City of Detroit
**City Engineering Division, Department of Public Works
Survey Bureau**

NOTICE OF PROPOSED CHANGE IN PROPERTY

Petition: x736

PETITION NO. 736
 BEDROCK REAL ESTATE SERVICES
 1092 WOODWARD AVE.
 DETROIT, MICHIGAN 48226
 C/O SCOTT R. COLLINS
 PHONE NO. 313 373-8700

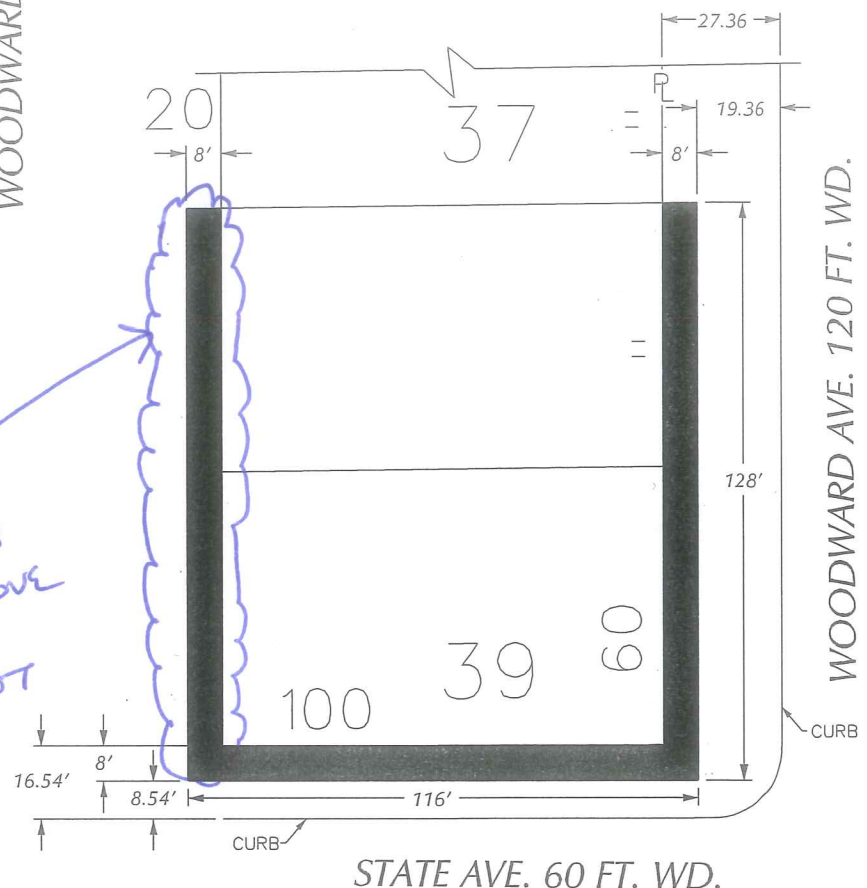
- Involved; but asking you to hold action on this petition until further notice. NOTE: DTE does not approve of alley encroachment due to multiple underground facilities impacted. Clearance and access to these facilities must be maintained at all times. DTE approves of Woodward and State right of way encroachment. (see attached diagram)
- Involved; but no objections to the property change.

DTE DOES NOT APPROVE OF ALLEY ENCROACHMENT
